COUNCIL ASSESSMENT REPORT

Panel Reference	PPSSNH-462
Parent DA Number	DA0197/18
eMOD Number	eMOD0047/23
LGA	Ku-ring-gai
Proposed Development	Section 4.56 Modification to Land and Environment Court Approval 391613 of 2018 (DA0197/18) proposing various internal and external changes to the approved mixed-use development, including changes to signage - Heritage Item
Street Address	1 and 1A Balfour Street, Lindfield (formerly known as 376-384 Pacific Highway, 386-390 Pacific Highway and 1 Balfour Street, Lindfield)
Applicant/Owner	Knight Frank Town Planning / PPI Lindfield Developments Pty Ltd
Date of eMOD lodgement	7 February 2024
Total number of Submissions	One submission
Recommendation	Approval
Regional Significant Development (Schedule 6 of the SEPP (Planning Systems) 2021)	A Section 4.56 modification application to a development with a capital investment value of more than \$30 million.
List of all relevant s4.15(1)(a) matters	<ul style="list-style-type: none"> • Environmental Planning and Assessment Regulation 2021 • State Environmental Planning Policy (Resilience and Hazards) 2021 • State Environmental Planning Policy (Transport and Infrastructure) 2021 • State Environmental Pla

Figure 3: Height Blanket Diagram and Schedule of Amendment at roof top level

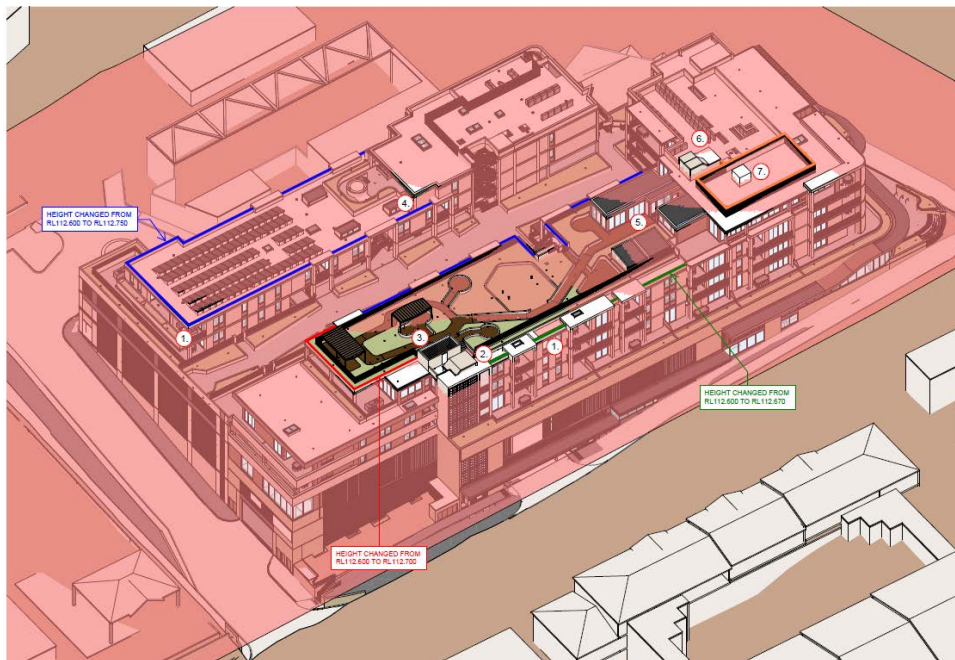
The greatest building height variations are confined to service elements of the development, specifically Coles smoke exhaust enclosure (2.35m variation), roof to fire stair 04 (2.25m variation) and plant enclosure for chiller equipment (1.98m variation). These elements are necessary for the proposed uses within the development and are generally set back from the edges of the building.

These elements will not result in any additional view, solar access, visual amenity or privacy impacts (beyond the approved development), nor materially add to the bulk or scale at the top of the building when viewed from the public domain and adjoining properties.
